802.3dj - Comments D1.1

Annex 179A - TBDs

- Comments D1.1 - D1.1- 179A.5 - TBDs
 - Mated Test Fixture
 - TP0d-TP2, TP3-TP5d

Figure 179A-3—Host-Nominal to Host-Nominal, Cable assembly, and test fixture insertion loss at 53.125 GHz

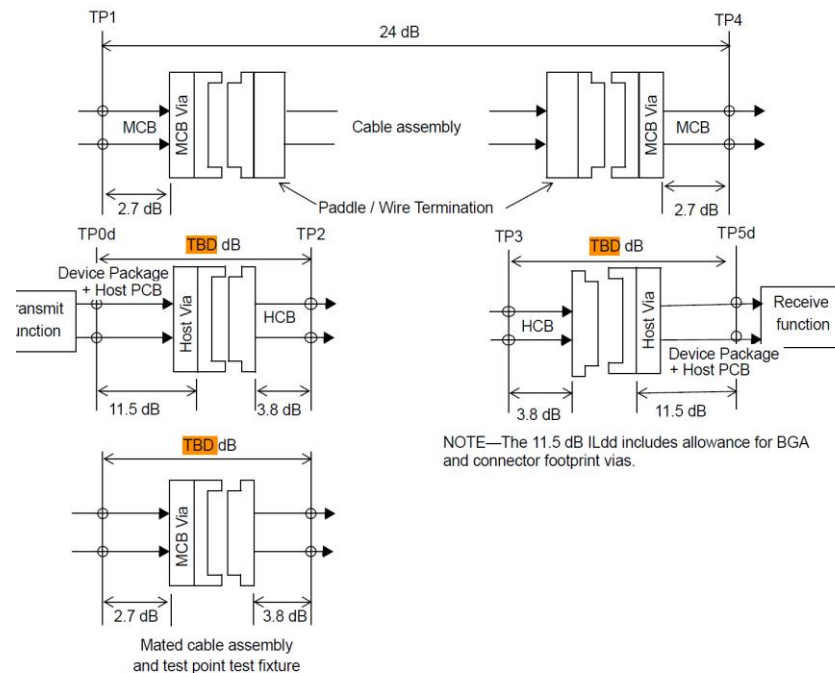
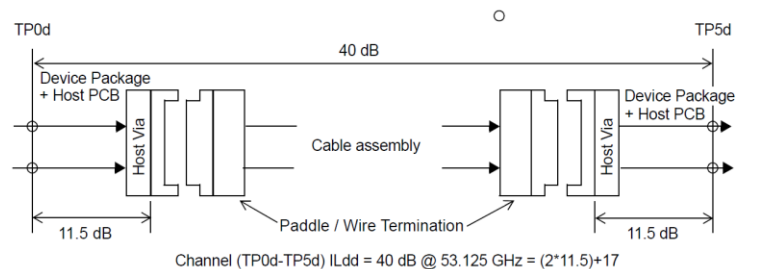
Ghiasi, Ali Ghiasi Quantum/Marvell
 Comment Type T Comment Status A HCB and MCB

MCB via allowance and HCB are TBD

See Ghiasi C2M May-24 presentation
 MCB via = 0.8 dB
 HCB=3.8 dB to allow practical implementations

ACCEPT IN PRINCIPLE.

Note that the value of HCB loss appears 3 times in the diagram.
 Implement the suggested remedy with editorial license.

NOTE (TBD)—2.7 dB MCB PCB ILdd includes the RF connector (up to the RF connector reference plane). The MCB via allowance is 0.8 dB.

Figure 179A-3—Host-Nominal to Host-Nominal, Cable assembly, and test fixture insertion loss at 53.125 GHz

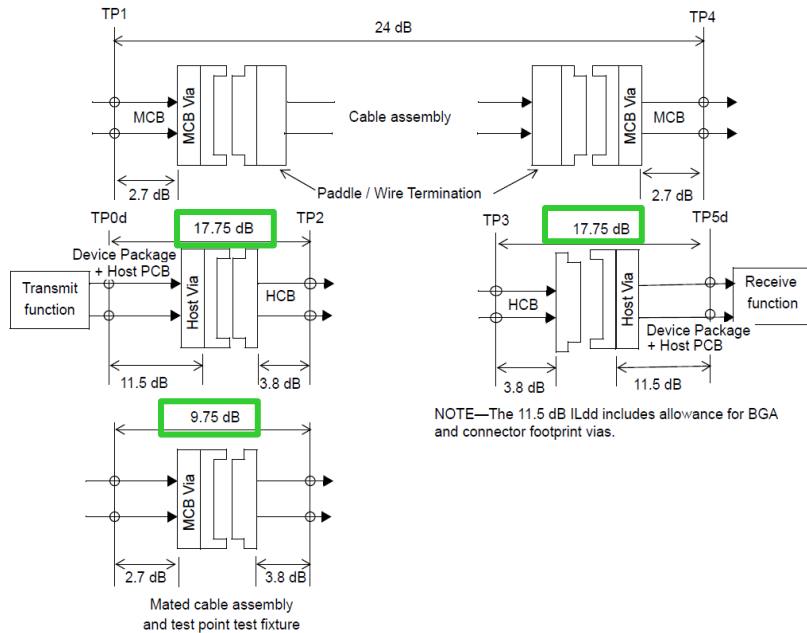
- 179A.5 - TBDs; Mated Test Fixture 9.75 dB @53.125 GHz, TP0d-TP2, TP3-TP5d (Table 179A-1)

NOTE—The 11.5 dB ILdd includes allowance for BGA and connector footprint vias.

Host designation	Host channel		TP0d to TP2 or TP3 to TP5
	Max (dB)	Min (dB)	Max (dB)
Host-Low (HL)	6.5	TBD	12.75
Host-Nominal (HN)	11.5	TBD	17.75
Host-High (HH)	16.5	TBD	22.75

NOTE (TBD)—2.7 dB MCB PCB ILdd includes the RF connector (up to the RF connector reference plane). The MCB via allowance is 0.8 dB.
